ADDENDUM | No. 2

Tea Law Enforcement Center

Project #: 23292.00.00

ISSUE DATE April 13, 2021

A-801R

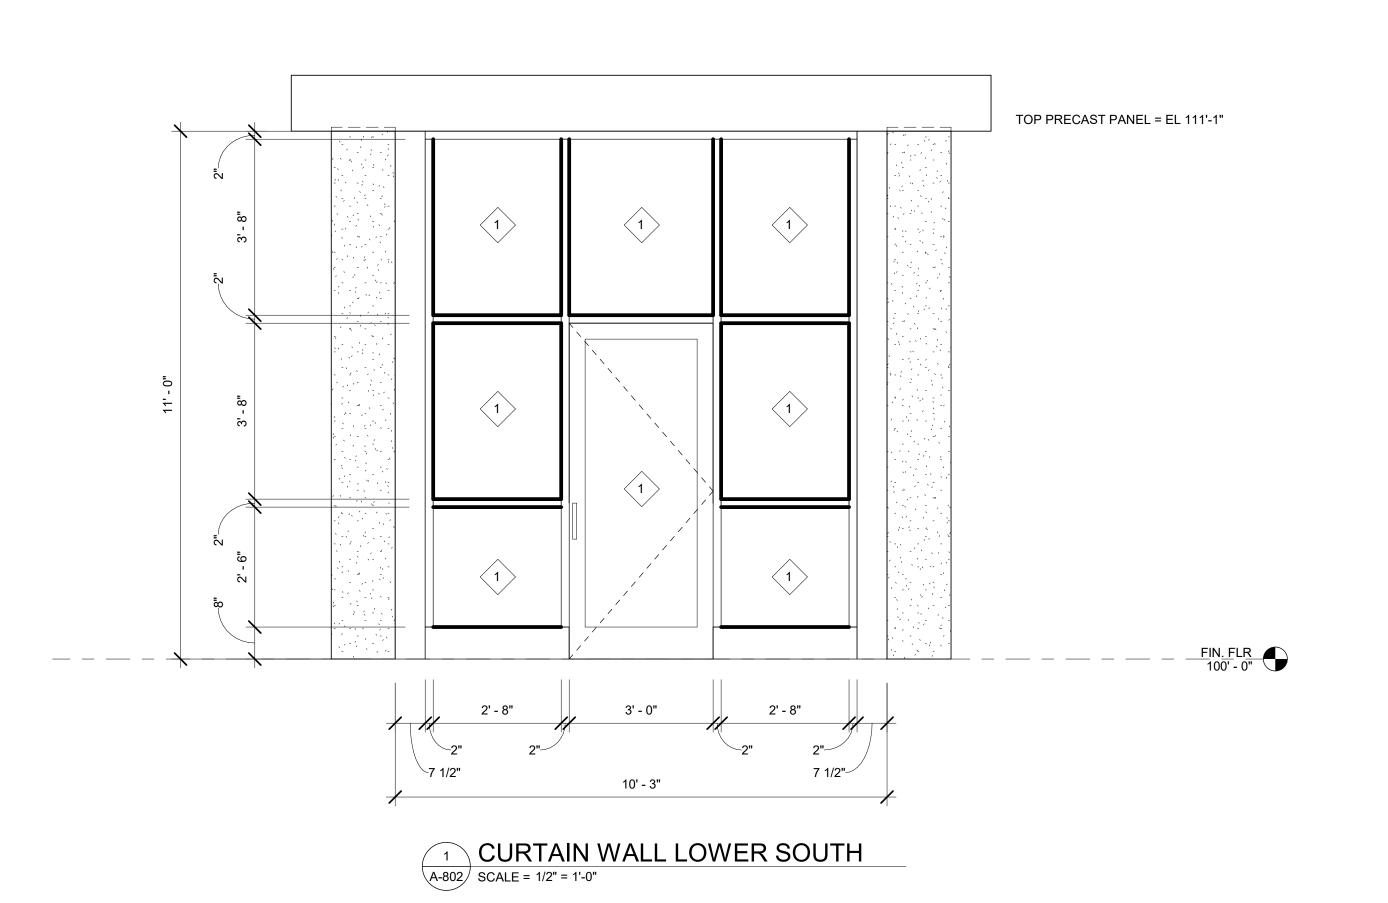
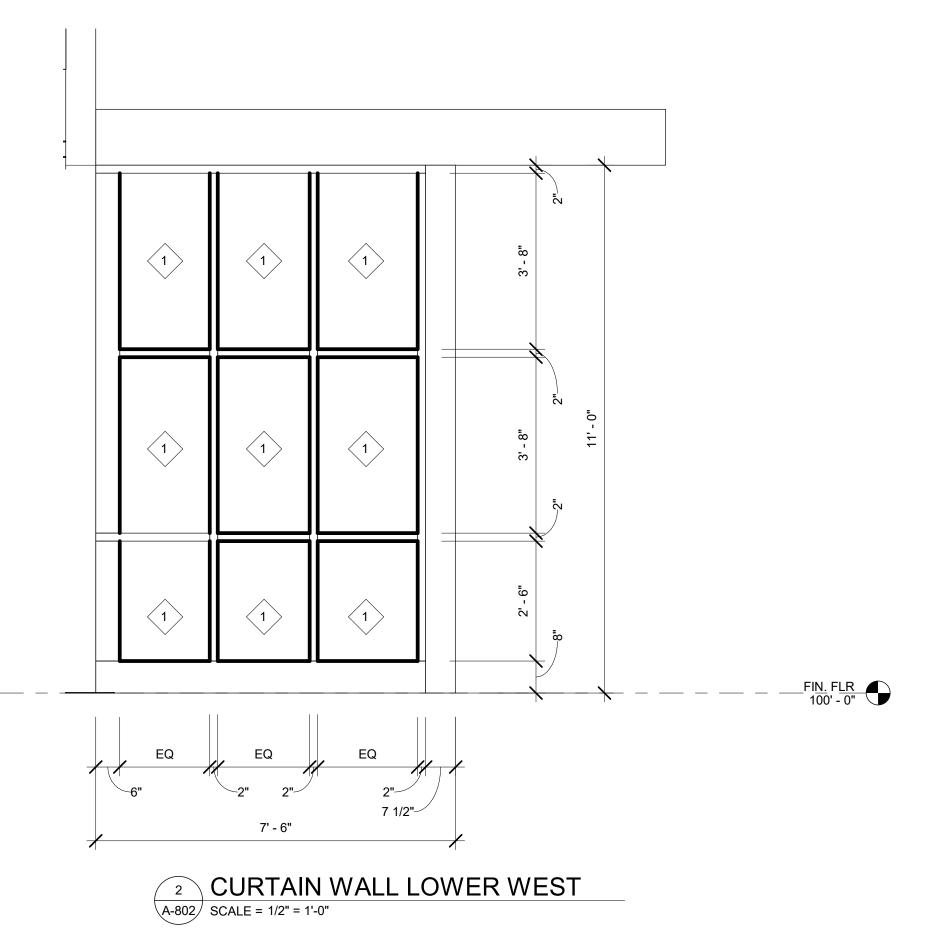
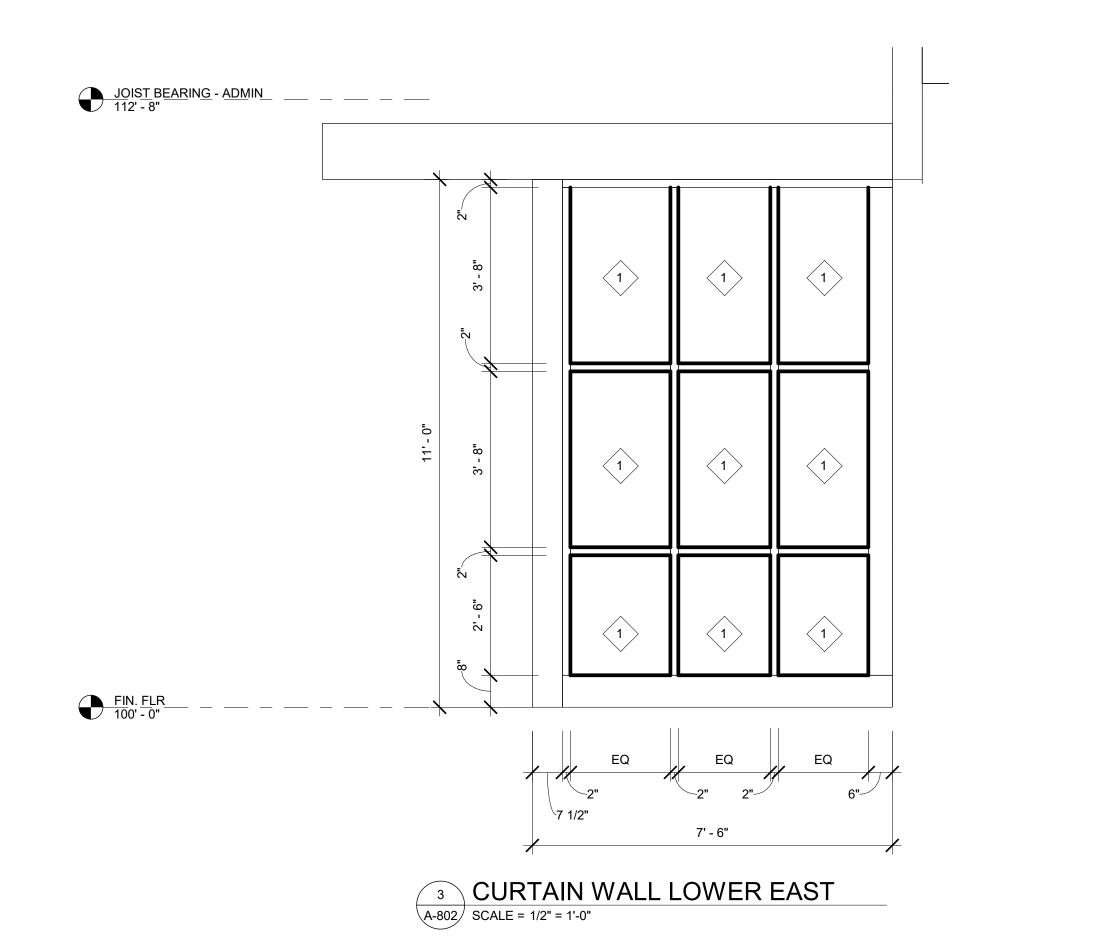
Drawing Sheet A-801 - Door & Window Elevations

Drawing Sheet A-801 in its entirety.

New Drawing Sheet <u>A-801R – Door & Window Elevations</u> – Refer to Attachments for new Drawing.

A-802R

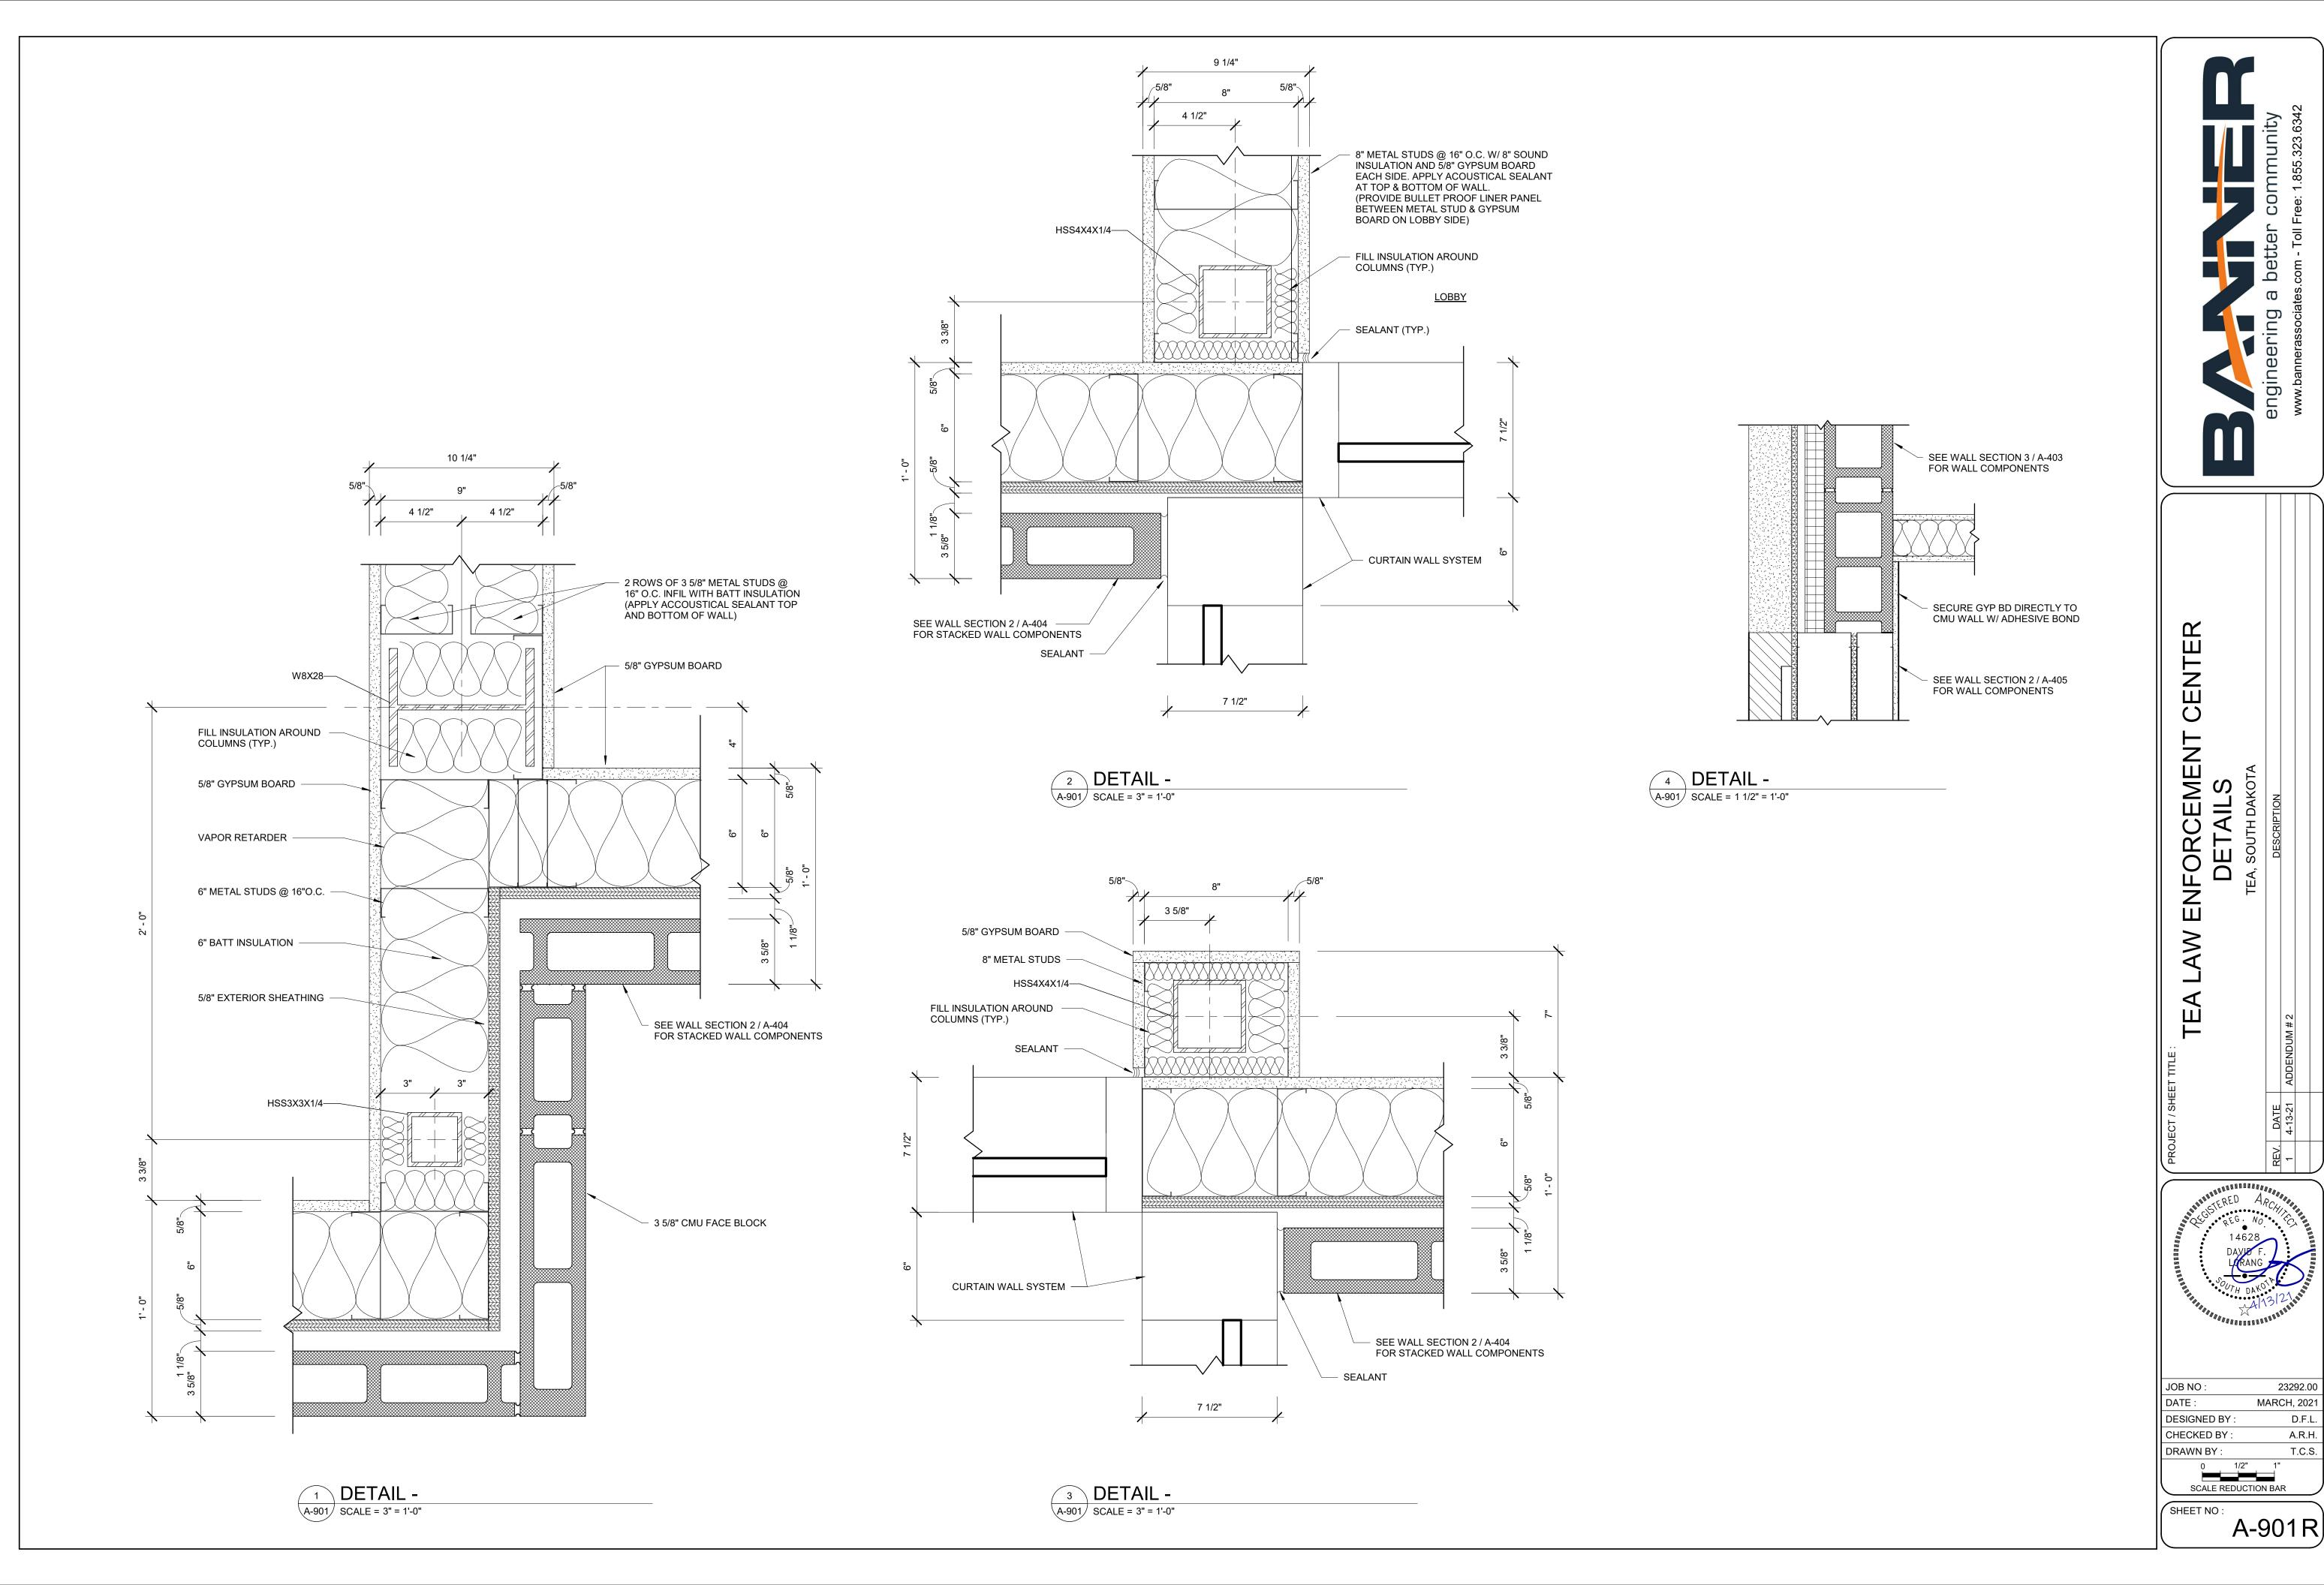
Drawing Sheet A-802 – Door & Window Elevations

Drawing Sheet A-802 in its entirety.

New Drawing Sheet <u>A-802R – Door & Window Elevations</u> – Refer to Attachments for new Drawing.

A-906R

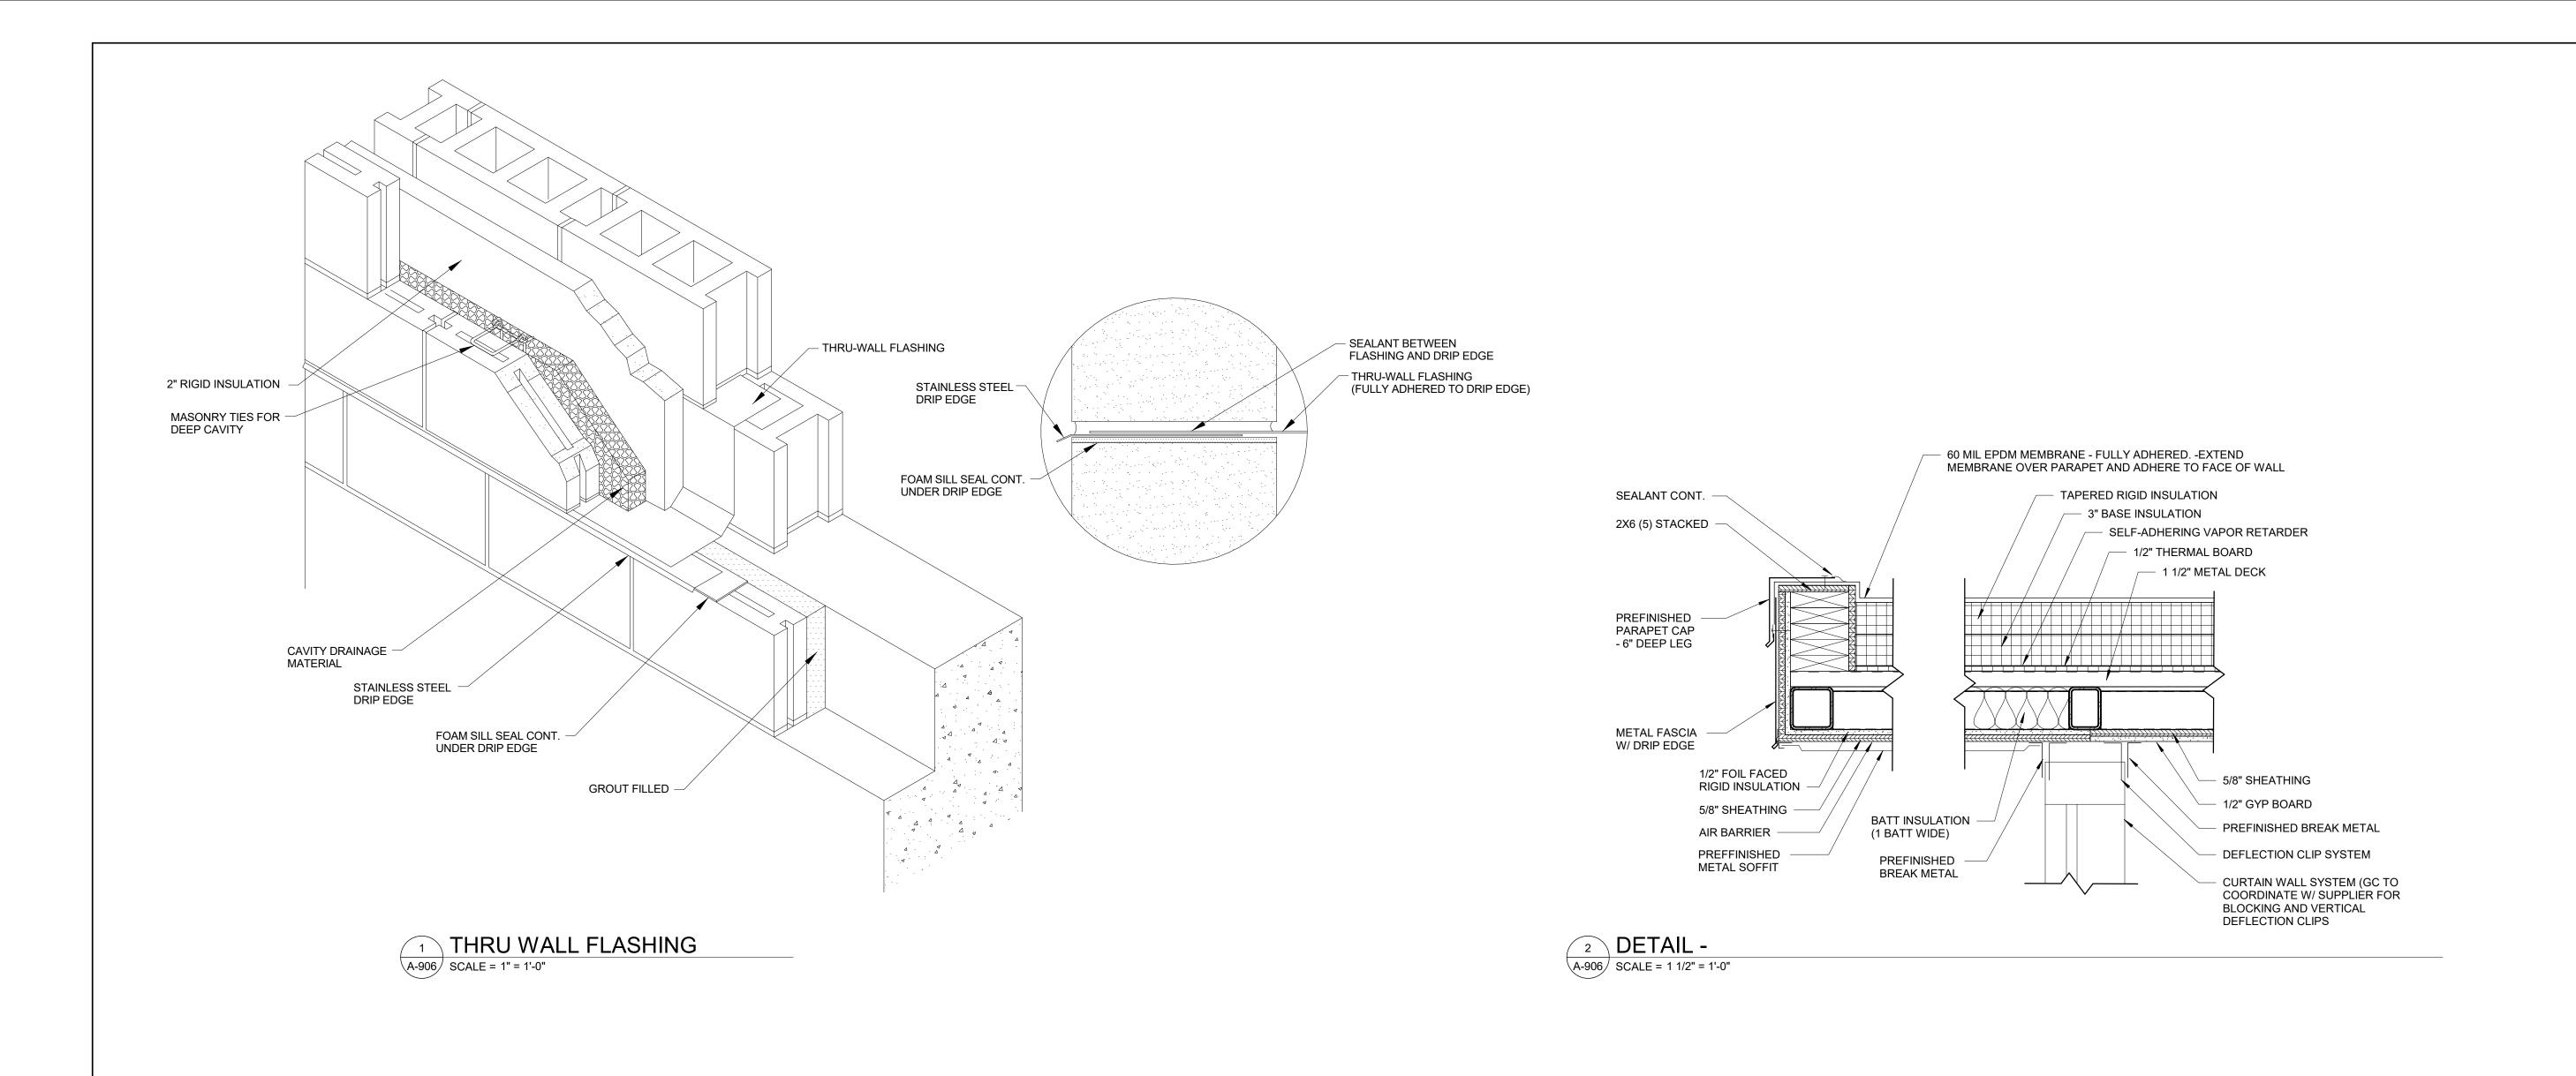
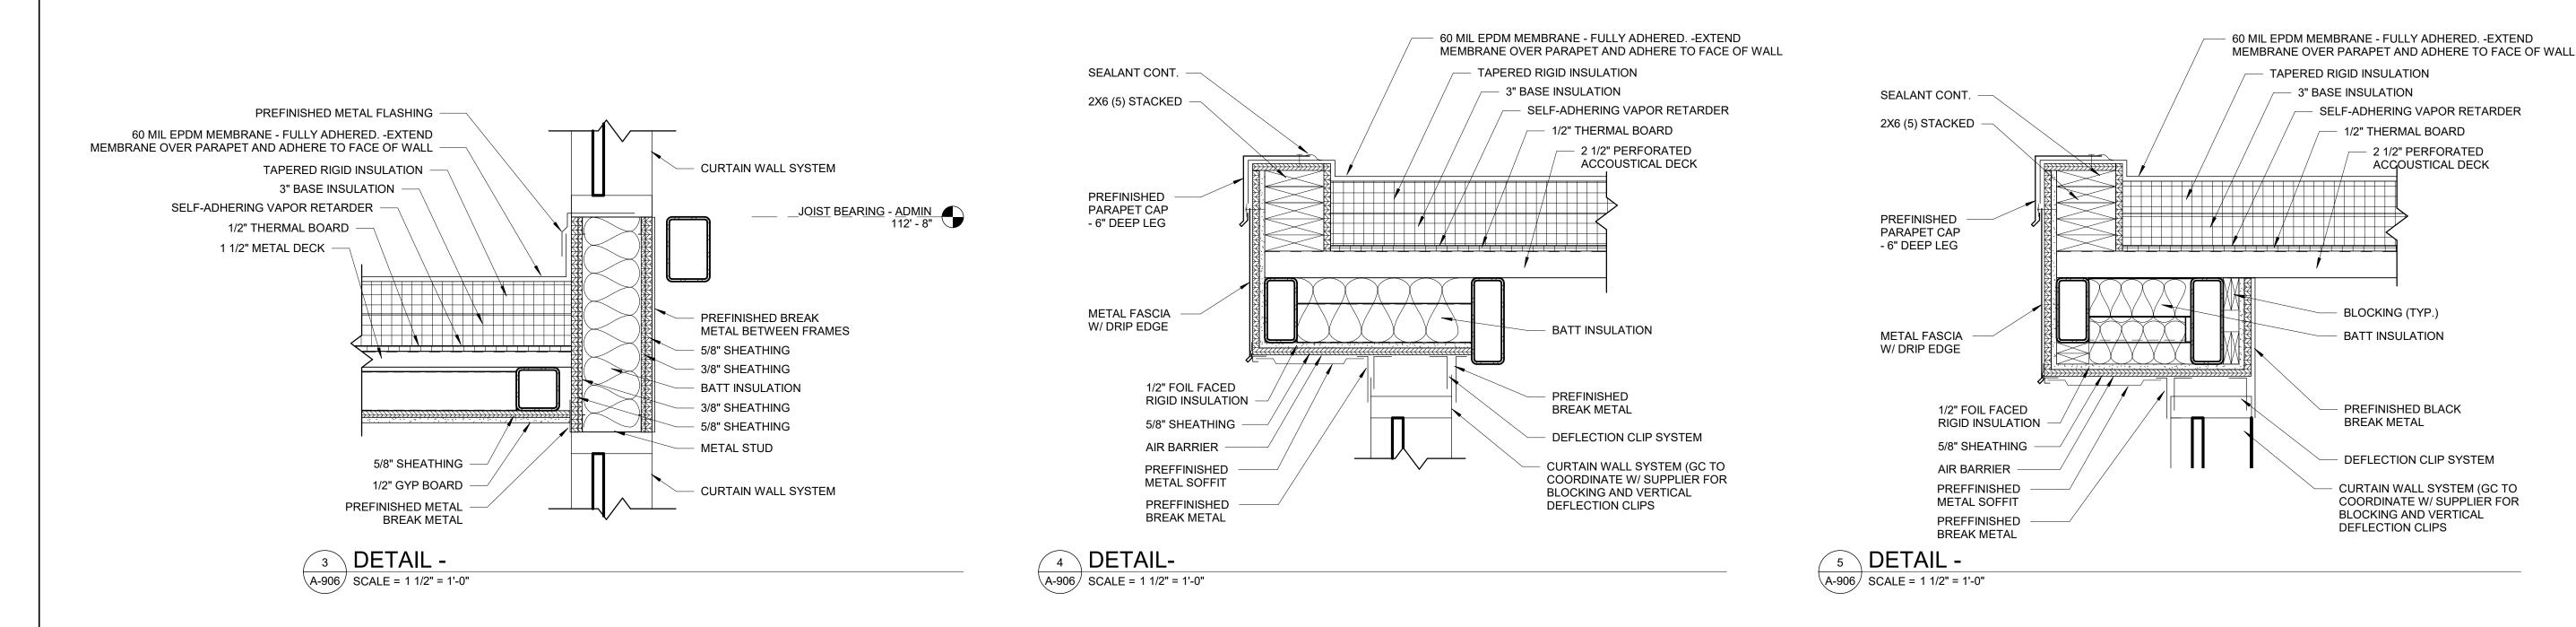
Drawing Sheet A-906 - Details

Drawing Sheet A-906 in its entirety.

New Drawing Sheet <u>A-906R – Details</u> – Refer to Attachments for new Drawing.
